Annex 5: HW change description v1.2 to Test Report 20-1-0017102T03a-C01-A5

Hardware change description
SICK LOCU1xx – UWB TAG

v1r3 -> v1r3.1 change description

Details for changes of LOCU Battery Basic/Advanced bottom layer:

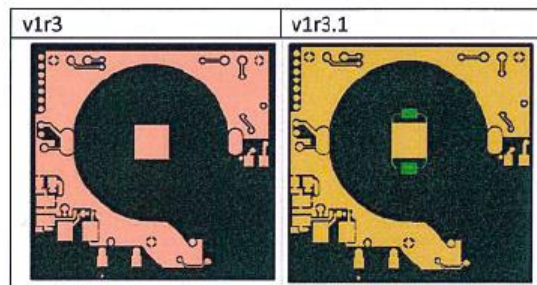
1. Battery holder: Pad adjustment of negative battery contact- milled grooves for battery holder are shifted in v1r3.1 comparing to v1r3. The pitch of grooves is increased by 0,45 mm.

- red mark - v1r3
- green mark - v1r3.1
